Groundwater Transfer Review Summary Form

Transfer/PA # T- 13432 (RA)

Application: T-13432

Applicant Name: Loen Nursery, Inc.

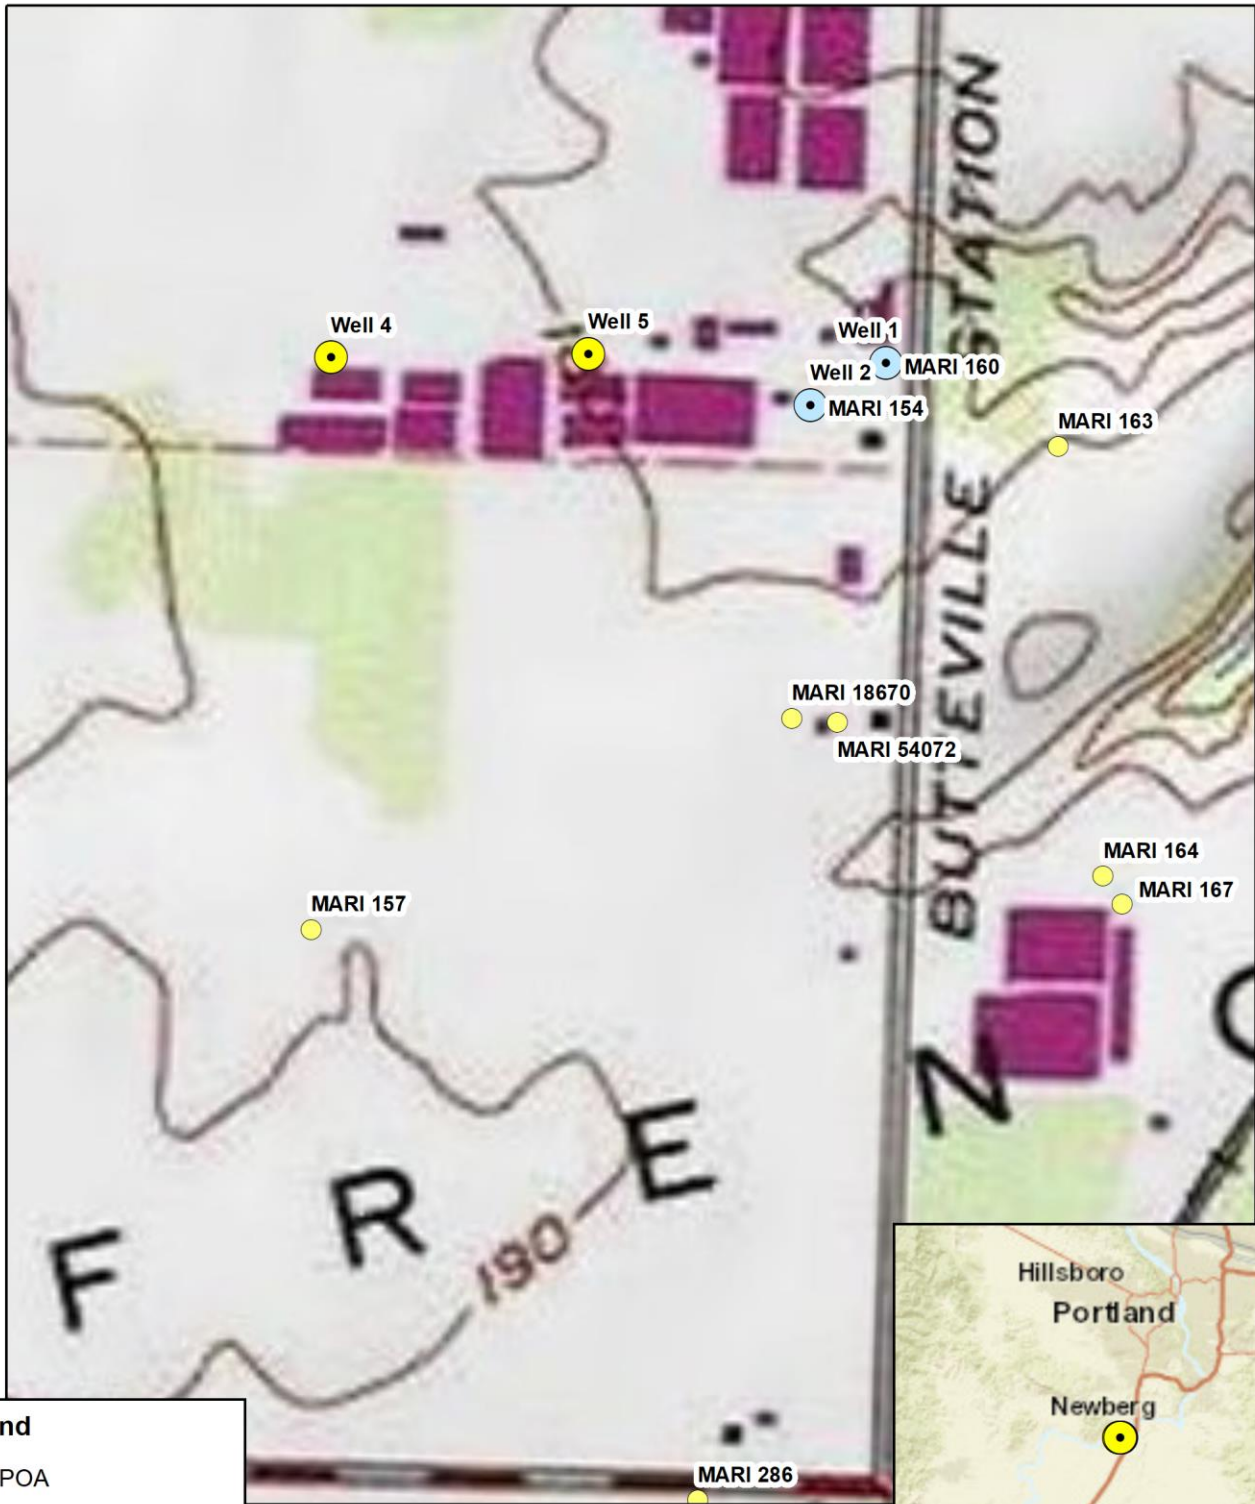
Results of the interference analysis indicate that, under the maximum continuous pumping scenario (264 days at 2.23 cfs followed by 101 days at 3.34 cfs), interference with **MARI 157** could exceed 42 ft (see attached Well Interference Analysis). The nearest relatively recent water level observation data (**MARI 55865**, 145.25 ft msl on 3/8/2006) suggests that **MARI 157** should have an available drawdown of ~180 ft during the annual high water level. Long term water level observation data (**MARI 308**) suggests that seasonal water level fluctuations may be ~30 ft or more between the annual high and annual low water level in this aquifer system. As such, at the seasonal low, the available drawdown in **MARI 157** may be only ~150 ft. The anticipated interference with **MARI 157** from proposed APOA Well 4 under the maximum pumping scenario would then represent ~28 percent of the available drawdown in **MARI 157**. **As such, it is not anticipated that the proposed change would deprive MARI 157 or similar neighboring wells of their customary use of groundwater.**

Well Location Map

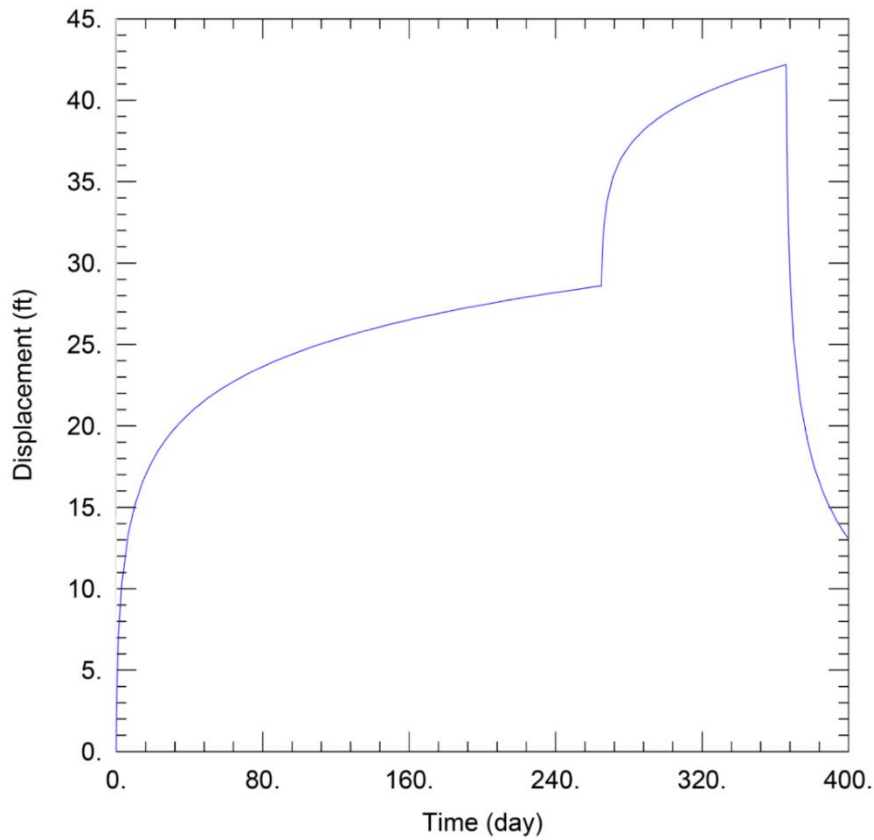
Yes No Comments: Proposed APOA Well 4 would be ~390 ft (~21%) closer to neighboring alluvial well MARI 157 than authorized POA Well 2 (MARI 154). APOA Well 4 would be ~610 ft (~29%) closer to MARI 157 than authorized POA Well 1 (MARI 160). The reduced intervening distance would likely increase the interference with MARI 157.
